APPENDIX C

Subject: Triangle - External works - Main entrance canopy

APPENDIX D

Made by: Checked by: Sheet No: 15 of

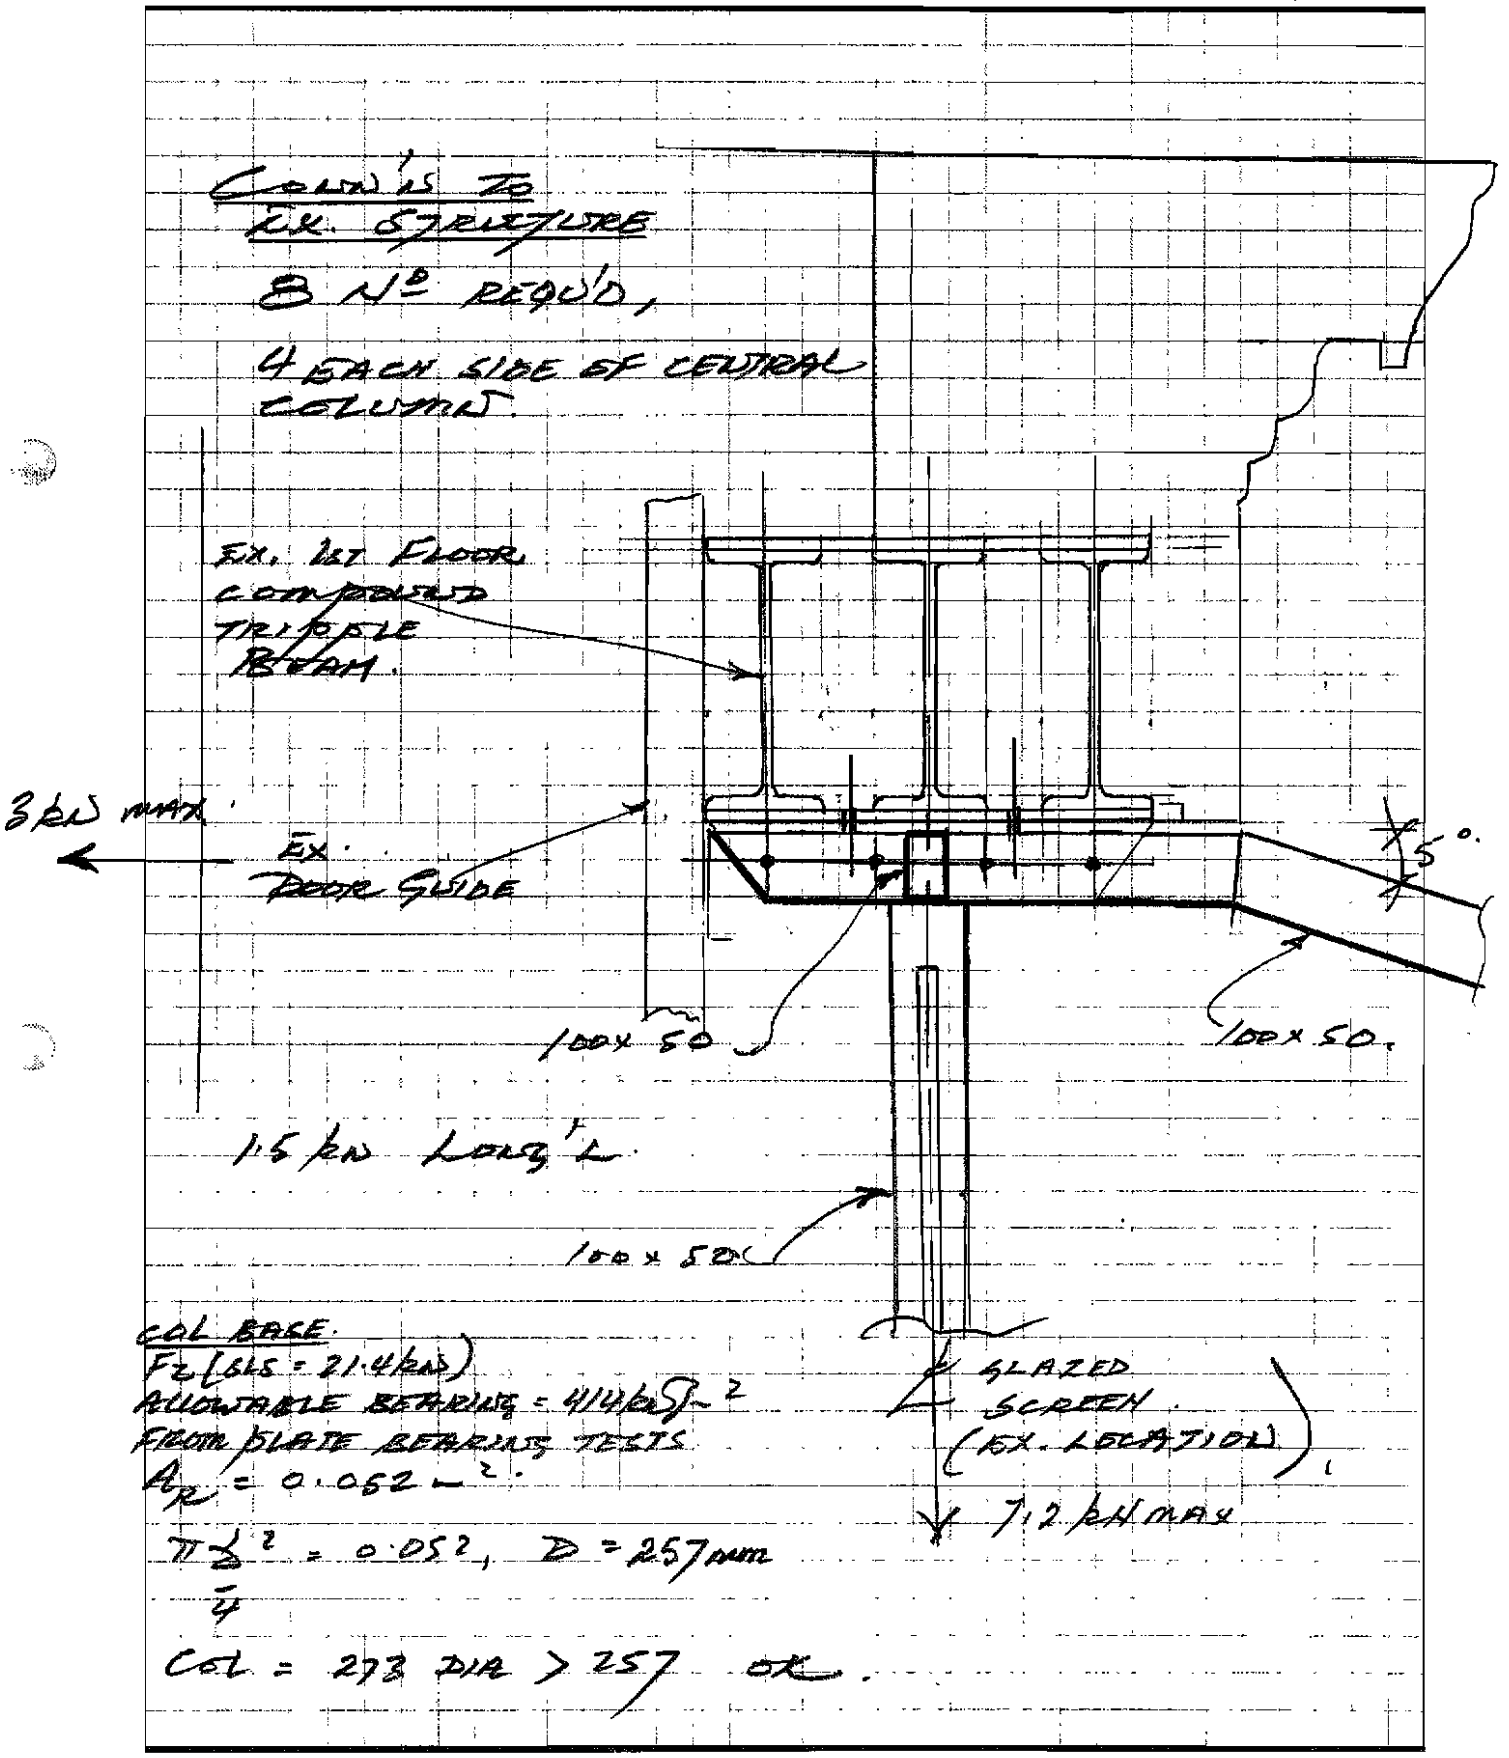
We have investigated the design of the main connection back to the existing first floor level compound steel beams. (Refer to the penultimate design sheet No. 20). This is the only structural zone available for connection other than taking support at the second floor level. The perimeter

The tie bar forces need to be transferred, via some tenuous bracketry, to the rear of the stonework, back to the triple compound steel beam section at first floor level. Access to the back of the stone is severely restricted by the roller shutter door mechanism and the tubular steel brace between masonry piers which cannot be removed. (Refer to attached photo's).

We are also unsure as to how the triple beam sections physically connect to the side and central columns. The significant torsion moments induced in the triple beams, from the canopy, will need to be transferred into and resisted by the building side columns which are currently embedded in masonry.

It is strongly recommended that alternative means of support be investigated to eliminate the need for the raking tie rods which induce the cantilever moment and torsion in the first floor level beams. This could be achieved by providing a pair of front posts thus eliminating the cantilever requirements at the building face. This is being investigated further.

FIGURE 1

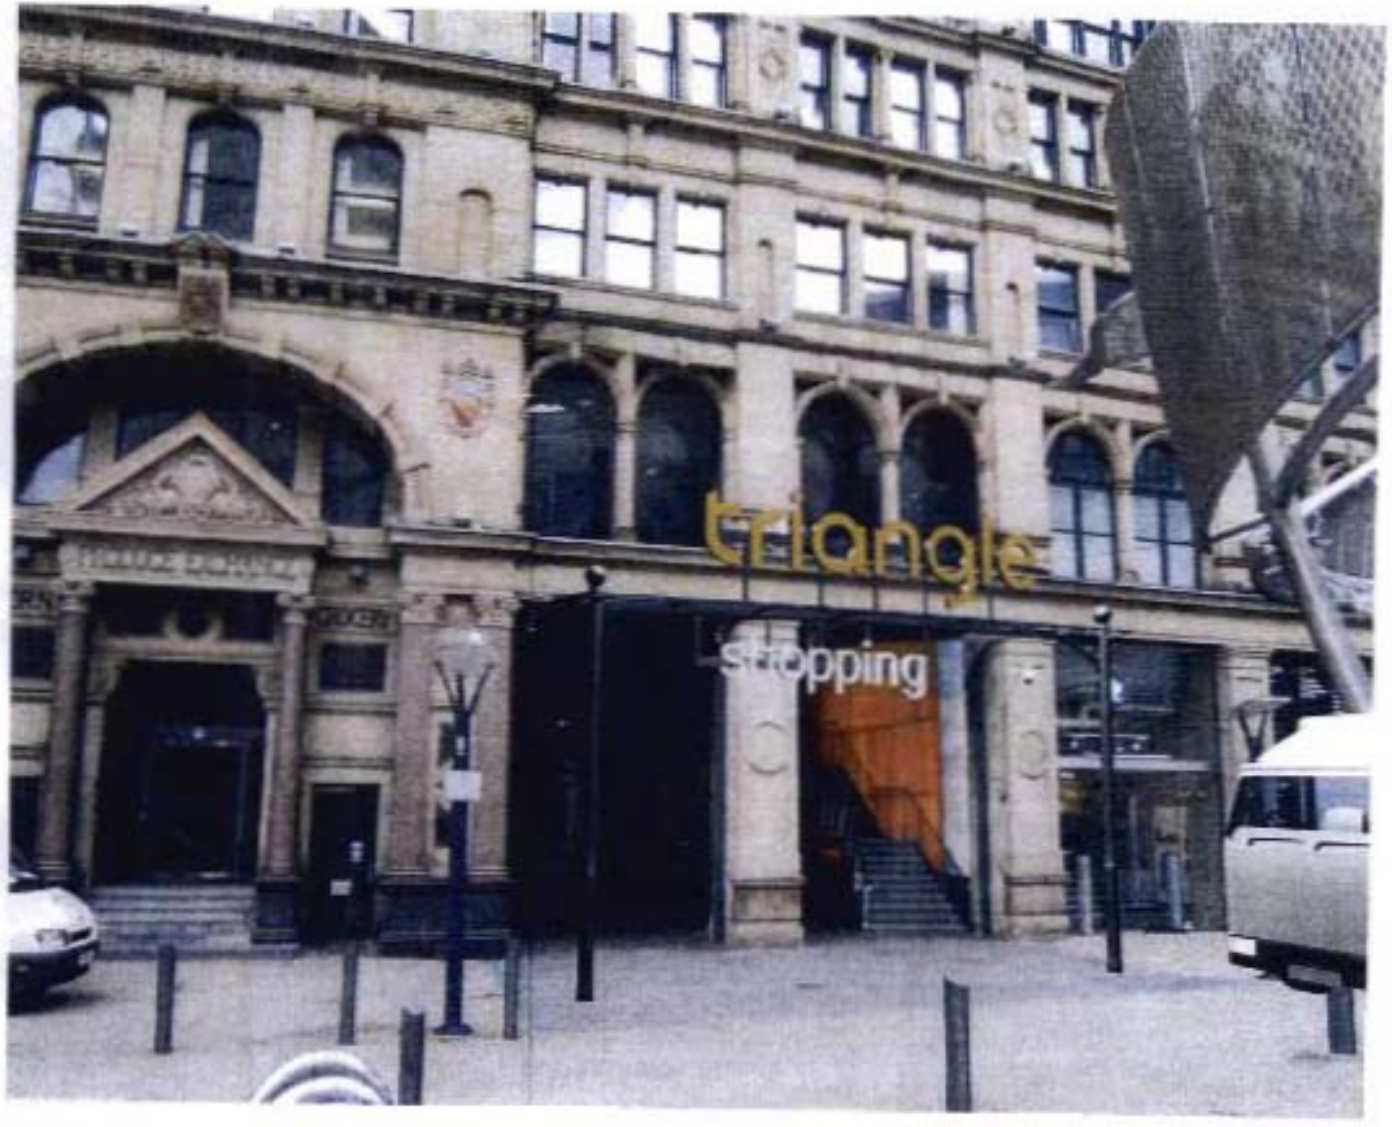
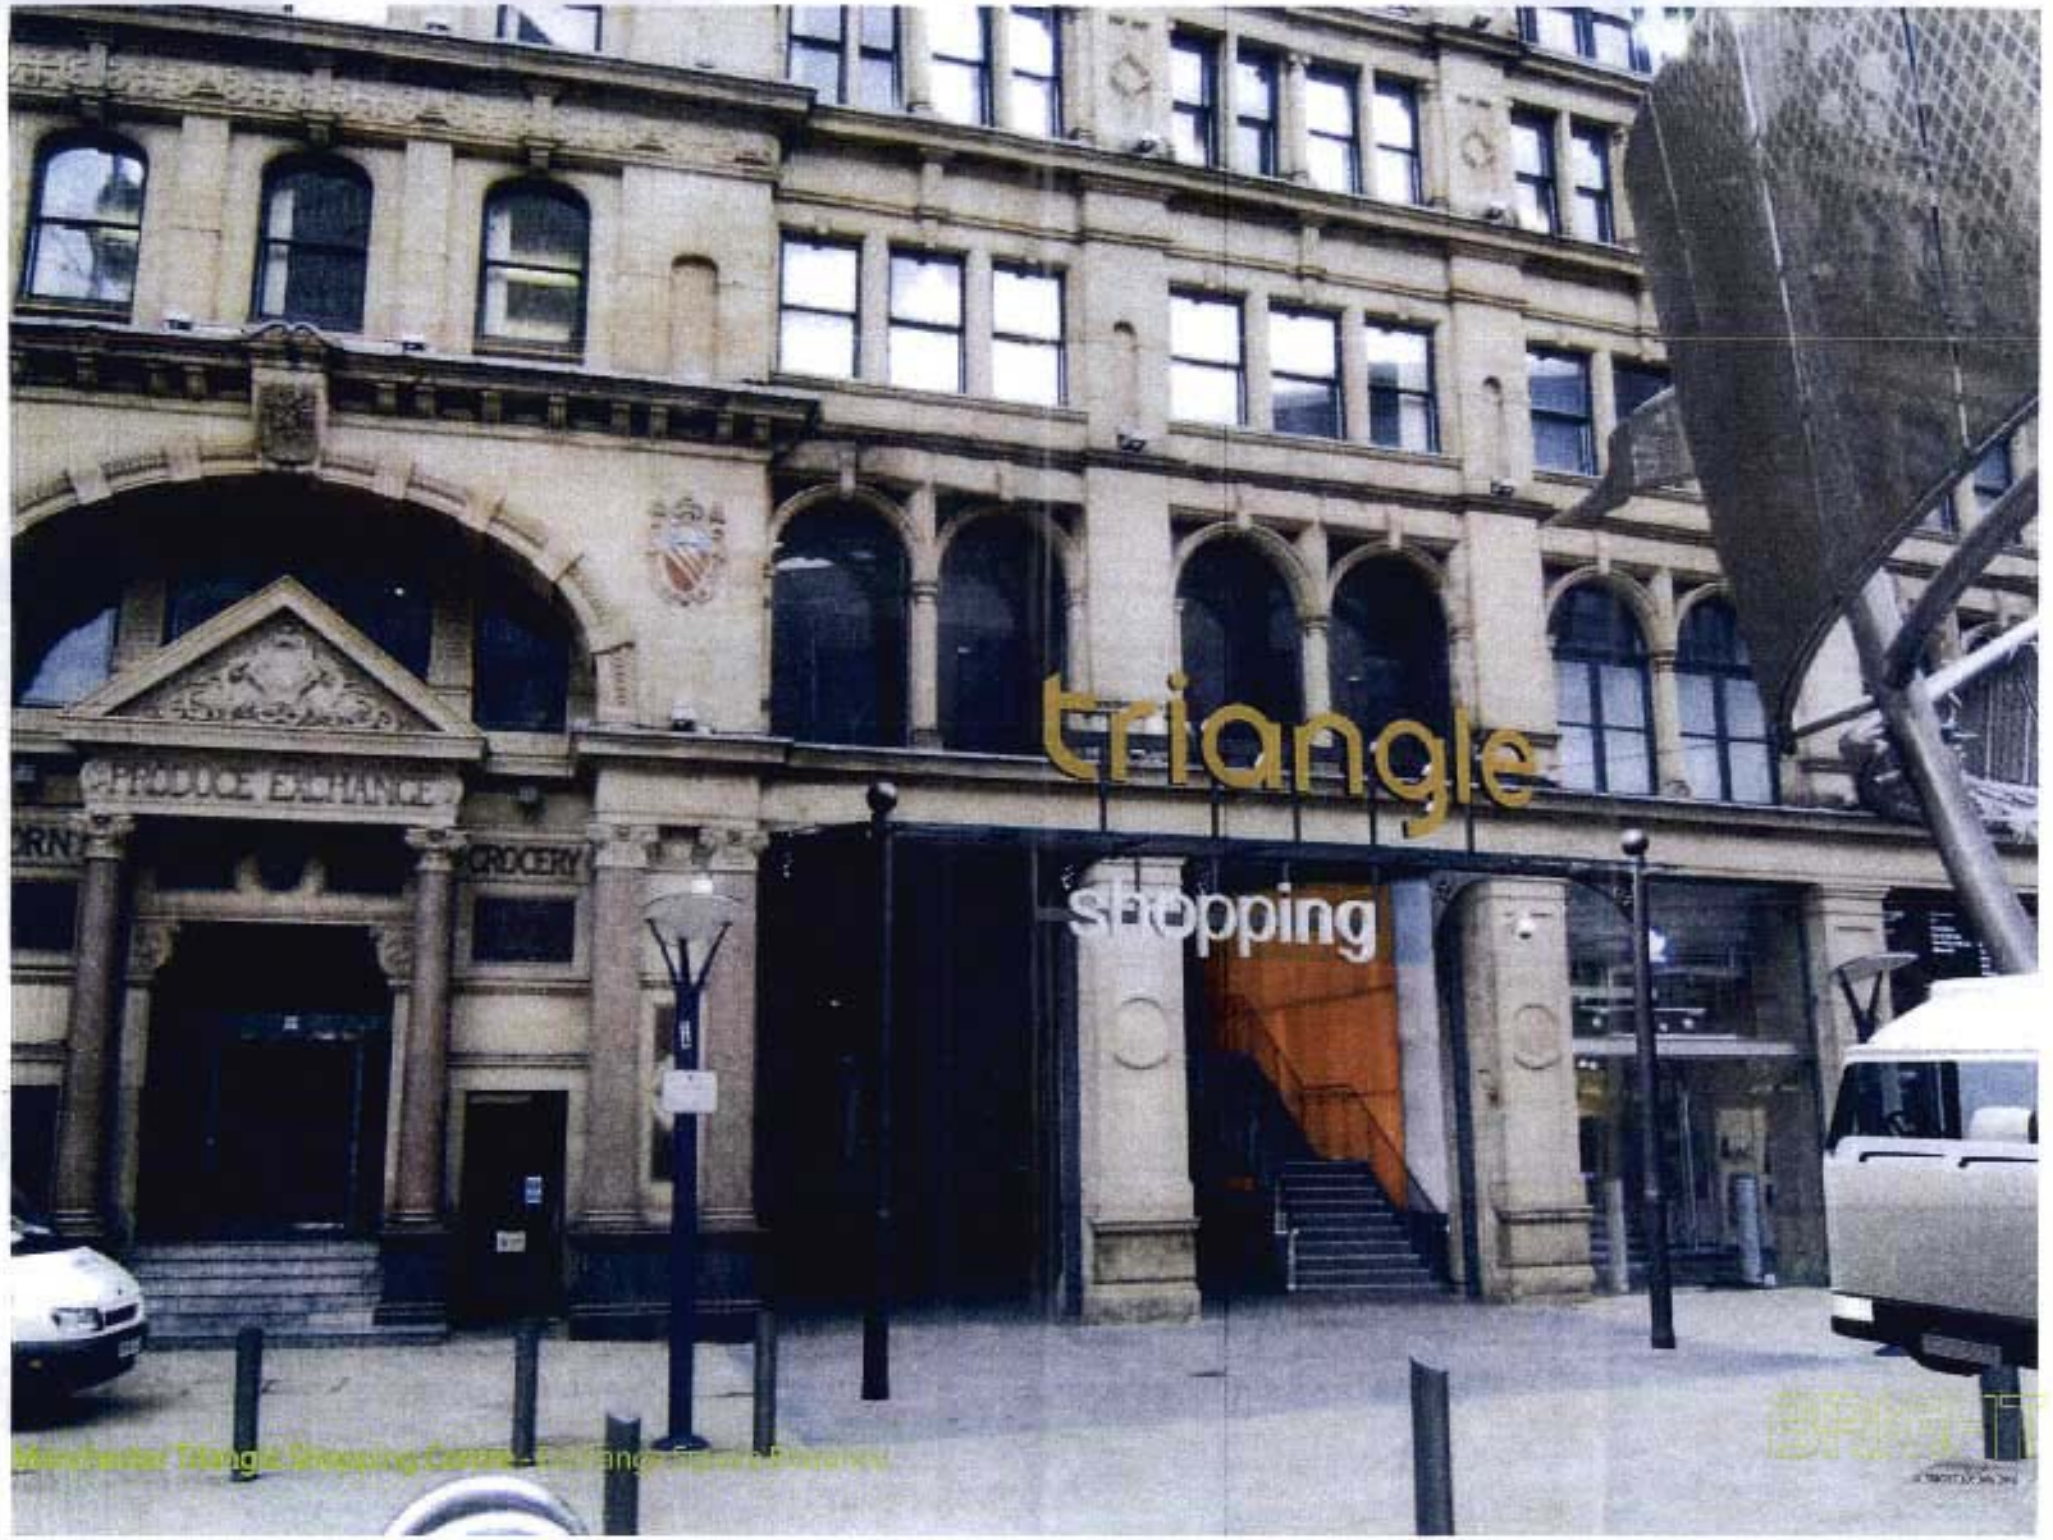
Having seen the pictures of the proposed changes to the entrance of the Triangle, I have no objections in principle. However as discussed, we would like bins with cigarette disposal units incorporated near to the entrance, and would like to have a say in the choice, this way keeping uniformity within the Public Realm.
